Access Compliance Report

Public Rights-of-Way

(Curb Ramps)

Intersection ID: 10141	Main Street: MILL_RD	Cross Street: W_TRADE_ST	Location:	N
ADA ID: C849326932BA	Ramp Type: Perp	Initial Pass/Fail: Fail	Overall Compliance: No	Severity Score: 12.5
Codes/Mitigation Info/Possible Solution		Field Measurements/Component Compliance

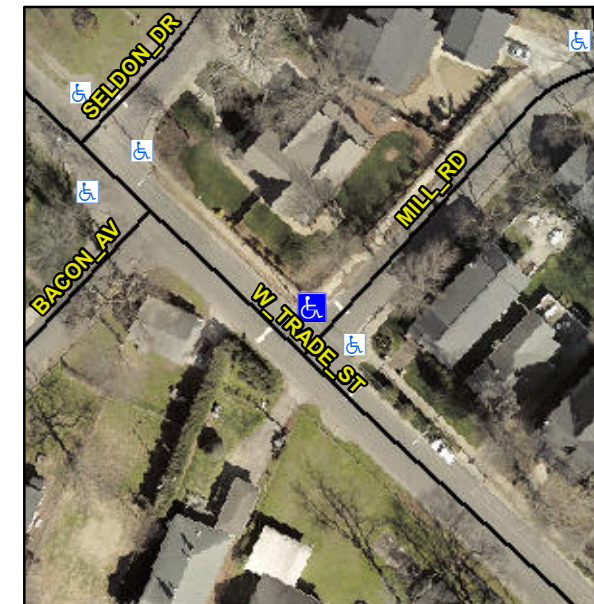
Not Found, R304.2.2

Compliance	Description	Data	Compliance	Description	Data
N/A	Ramp Length (in)	29.0	No	Ramp Slope (%)	11.0
Yes	Ramp Width (in)	48.0	Yes	Ramp XSlope (%)	1.9
N/A	Flare Type LT	N/A	N/A	Flare Type RT	N/A
N/A	Flare Slope LT (%)	N/A	N/A	Flare Slope RT (%)	N/A
N/A	Flare Traversable LT?	N/A	N/A	Flare Traversable RT?	N/A
N/A	Landing Length (in)	N/A	N/A	DWS Provided?	N/A
N/A	Landing Width (in)	N/A	N/A	DWS Contrast?	N/A
N/A	Landing Slope (%)	N/A	N/A	DWS Length (in)	N/A
N/A	Landing X Slope (%)	N/A	N/A	DWS Full Width?	N/A
N/A	Landing Curb? (Y/N)	N/A	N/A	DWS Offset (in)	N/A
N/A	Shared Landing?	N/A			
N/A	Gutter Ponding?	N/A	N/A	Gutter Slope (%)	N/A
N/A	Gutter Lip Ht (in)	N/A	N/A	Gutter X Slope (%)	N/A
N/A	Painted X Walk1?	No	N/A	Painted X Walk2?	N/A
	X Walk 1 Direction	To SE		X Walk 2 Direction	N/A
N/A	X Walk 1 Width (in)	N/A	N/A	X Walk 2 Width (in)	N/A
	X Walk 1 Slope (%)	3.0		X Walk 2 Slope (%)	N/A
	X Walk 1 X Slope (%)	2.5		X Walk 2 X Slope (%)	N/A

Remove & Replace Entire Ramp.
